HISTORIC AND DESIGN REVIEW COMMISSION

June 21, 2017

HDRC CASE NO: 2017-268
ADDRESS: 1934 W SUMMIT
LEGAL DESCRIPTION: NCB 1944 BLK 22 LOT 18
ZONING: R-6 H
CITY COUNCIL DIST.: 7
DISTRICT: Monticello Park Historic District
APPLICANT: Varco Builders of Texas
OWNER: Caleb Scott
TYPE OF WORK: Window relocation, window replacement, exterior modifications
REQUEST:

EXISTING FLOOR PLAN
1934 W. SUMMIT RESIDENCE
 Mi CAZA DESIGN ARCHITECTURE

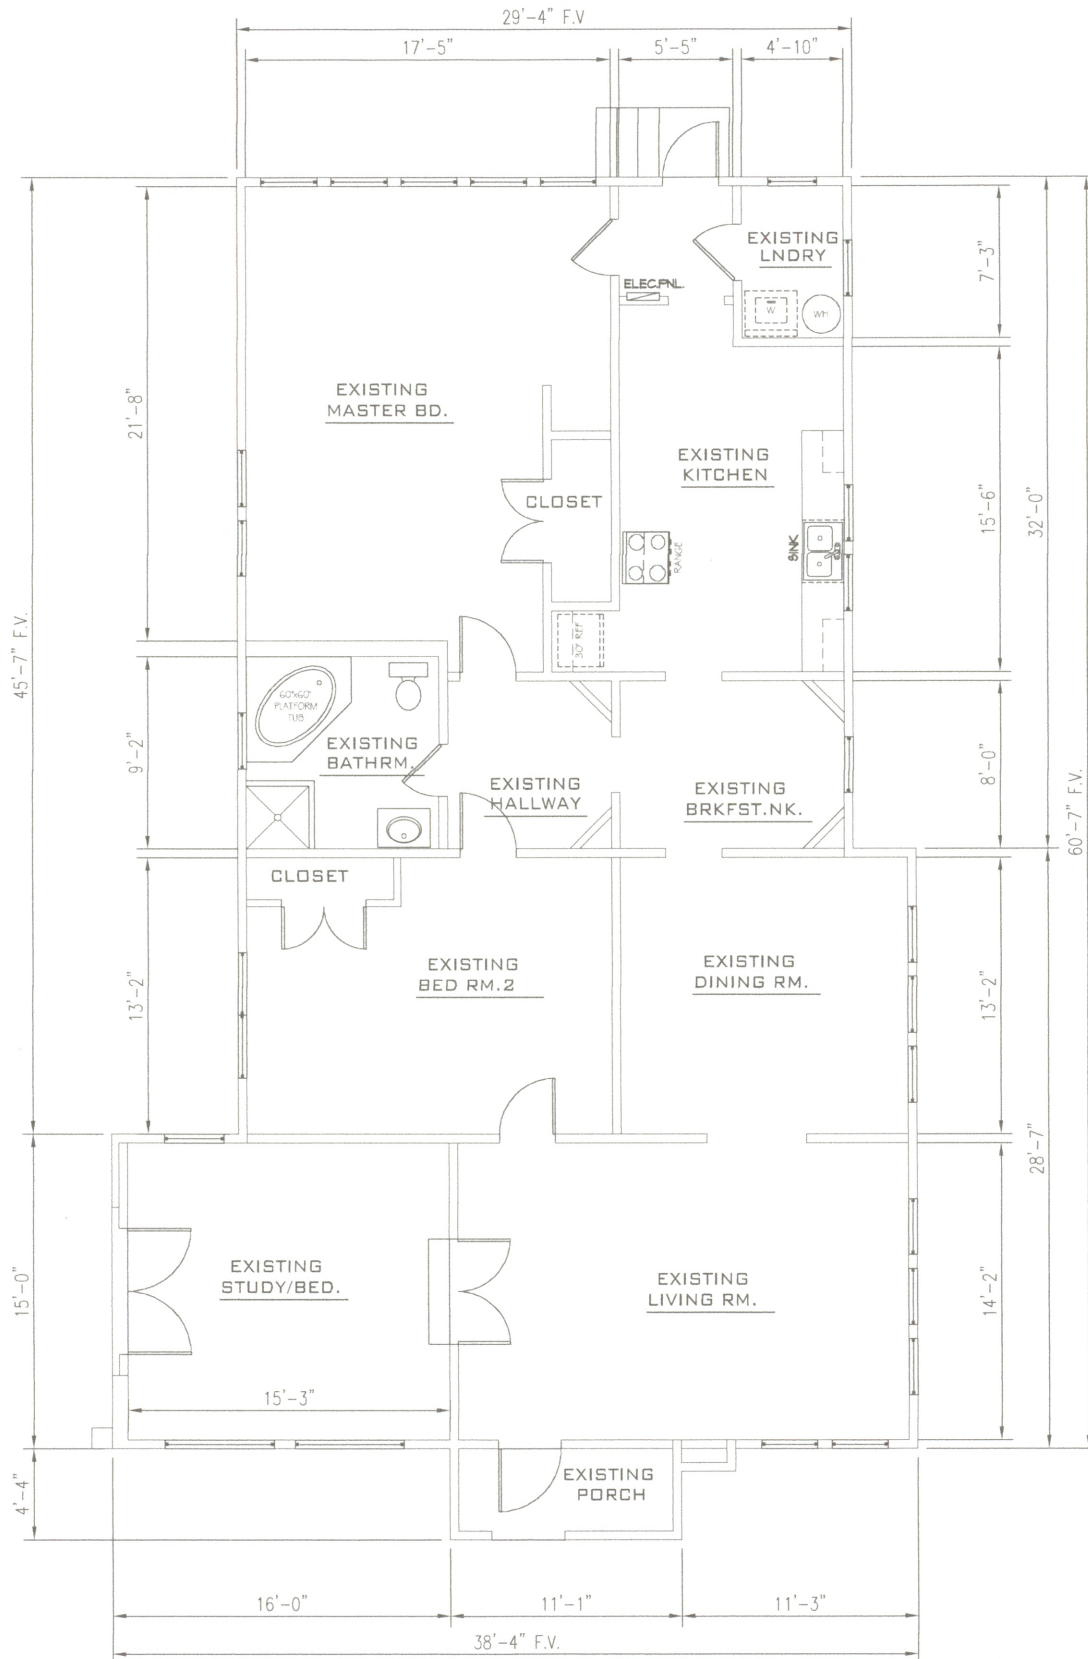
- c. WINDOW RELOCATION – Staff conducted a site visits on April 17, 2017, and again on June 8, 2017, to assess the condition of the windows and the property as a whole. Staff found that the five windows located on the rear façade of the structure are in excellent condition given their age (windows #14 through #18 on the submitted plans). Five out of six windows on east façade, closest to the public right-of-way, are the same size and configuration, but are in a state of disrepair due to direct sun exposure and faulty repair techniques over the years (windows #3 and #5 through #8 on the submitted plans; window #4 is in repairable condition). The applicant has proposed to relocate the five rear windows to the east side of the structure. Staff finds the proposal acceptable given the condition and the visibility from the public right-of-way of the windows on the east façade.

- d. WINDOW REPLACEMENT: REAR FAÇADE – The applicant has proposed to replace the relocated rear windows with new windows to match the existing in size, configuration, and profile. According to the Guidelines for Exterior Maintenance and Alterations, windows should be replaced with ones that match existing in terms of size type, configuration, material, form, appearance, and detail. Staff finds the proposal generally consistent with the guidelines, but has yet to receive final window specifications that indicate all of these details.

- e. ALUMINUM WINDOW REPLACEMENT – Two windows on the west façade were previously replaced with aluminum one over one windows (#22 and #23 on the submitted plans). The applicant has proposed to replace these windows with new windows to match the existing original windows on the structure in size, configuration, and profile. According to the Guidelines for Exterior Maintenance and Alterations, non-original windows should be replaced with ones that match those that would have been historically found on the structure in terms of size type, configuration, material, form, appearance, and detail. Staff finds the proposal generally consistent with the guidelines, but has yet to receive a final window specification.

- f. DRYWALL INSTALLATION: EAST FAÇADE – The applicant has proposed to install interior drywall behind two one over one windows on the east façade of the structure. The windows themselves will be rehabilitated and retained on the exterior. Staff finds the proposal acceptable.

- g. WINDOW REPLACEMENT: WEST FAÇADE – The applicant as proposed to replace two one over one wood windows and their central wood trim piece with a new solid pane fixed window. The surrounding original wood trim will remain on the interior and exterior, and the window pane will be custom fit to the opening. According to the Guidelines for Exterior Maintenance and Alterations 6.B.iv., windows should only be replaced if approximately 50% or more of the assembly is deteriorated beyond repair. If beyond repair, windows should be replaced with ones that match existing in terms of size type, configuration, material, form, appearance, and detail. Staff's site visit revealed that the windows are in good condition and can be repaired. Staff finds the proposal to replace existing wood windows inconsistent with the guidelines.

Item 1, Staff recommends approval of the relocation of five windows from the rear façade to five openings of the same size on the east façade based on finding c.

Item 2, Staff recommends approval of the replacement of the rear windows based on finding d with the stipulation that the applicant submits final window specifications to staff for approval. Staff finds wood windows to be appropriate.

Item 3, Staff recommends approval of the aluminum window replacement based on finding e with the stipulation that the

applicant submits final window specifications to staff for approval. Staff finds wood windows to be appropriate.

Item 4, Staff recommends approval of the drywall installation based on finding f.

Item 5, Staff does not recommend approval of the replacement of two wood windows with a single glass pane based on finding e.
